Staff Report

Detached Accessory Dwelling Unit – Conditional Use (PLNPCM2019-00349) Re:

PROPERTY ADDRESS: 815 E. Emerson Avenue

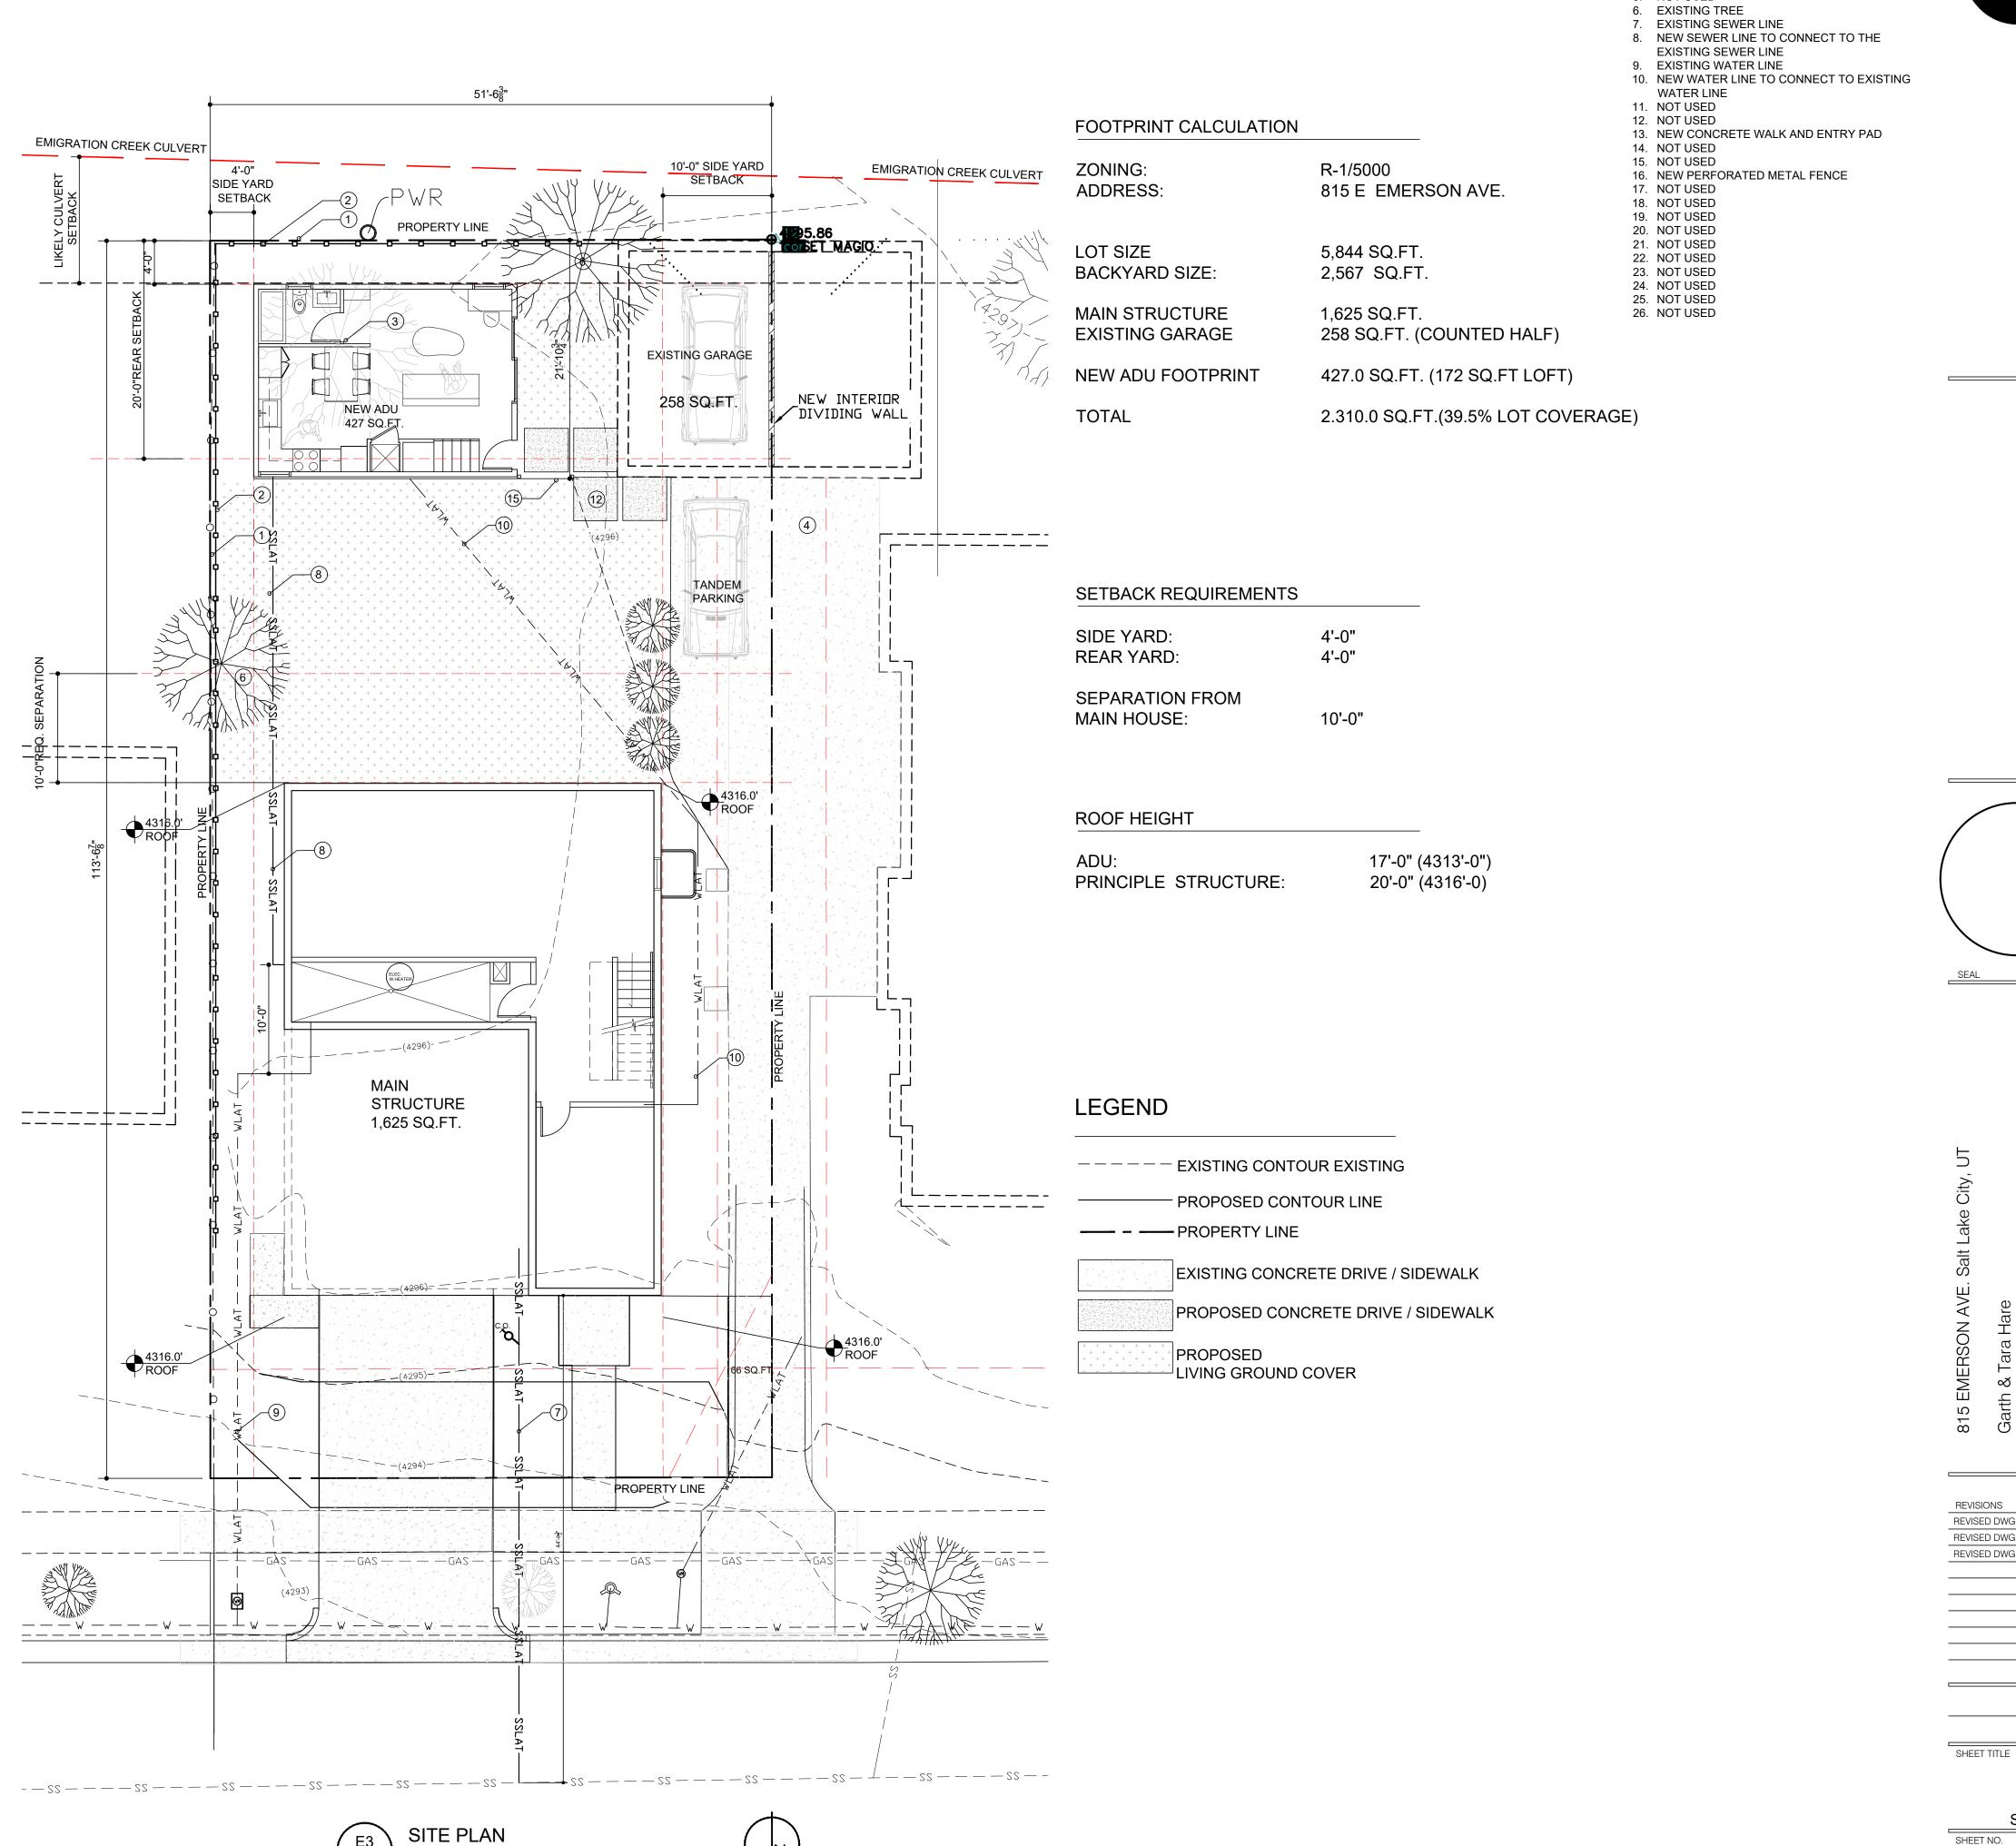
A fire hydrant must be within 400-feet of all exterior walls of the proposed unit. Identify location of existing or proposed hydrant(s)

The fire department access road must be within 150-feet of all portions of the exterior walls of the dwelling. This measurement is taken from the road and measured in straight lines and right angles in the route the hose would be pulled. Distances and route not provided.

There is a fire hydrant at the southside of 815 E. Emerson Ave. Please see new AS1.2 Fire Access Plan for the fire hydrant location and 400 feet circle centered on the hydrant to show the compliance.

Please see new AS1.2 Fire Access Plan for hose route and its' distance.

WEST ELEVATION

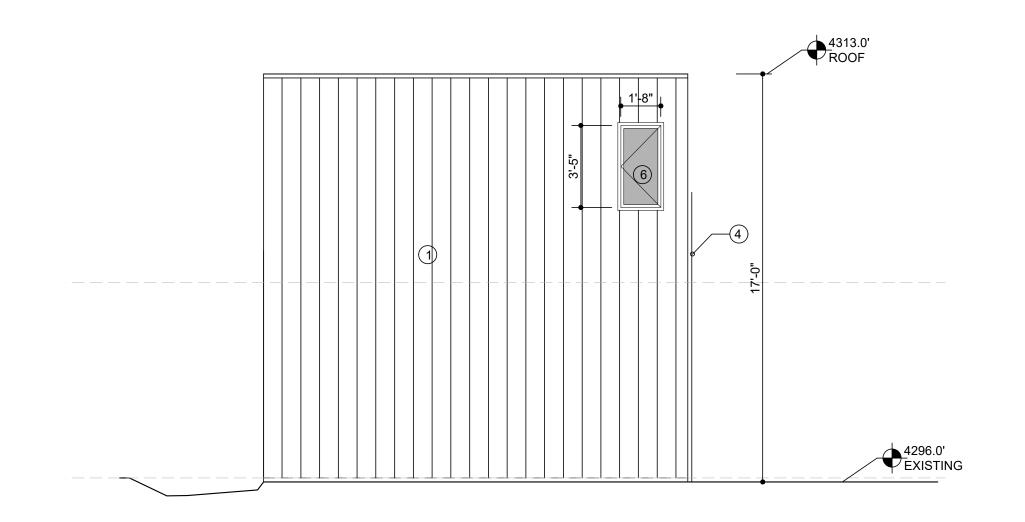
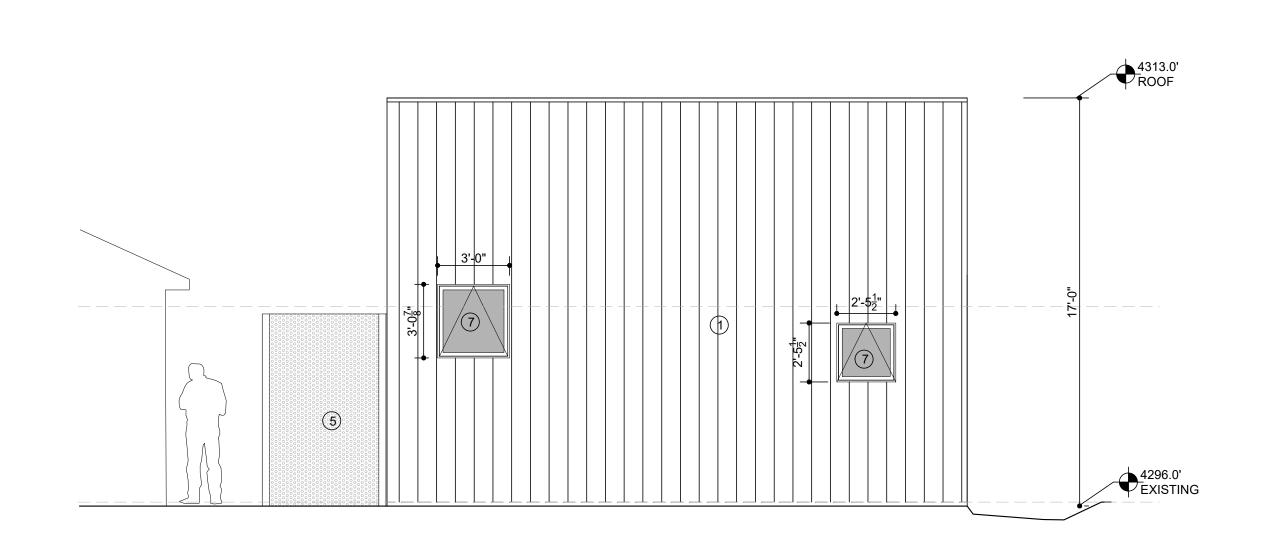
It is unclear if the proposed ADU to be located at 819 E. Emerson Ave. (the drawings show 815 E.) complies with section 21A.40.200.E.3.g: Requirements for Windows. Building code reviewer will need to determine if the proposed windows exceed the minimum Building Code requirement, which is not allowed. North and West facing windows require obscured glazing.

I have revised the west egress window dimensions and the type of glass on revise A2.1.
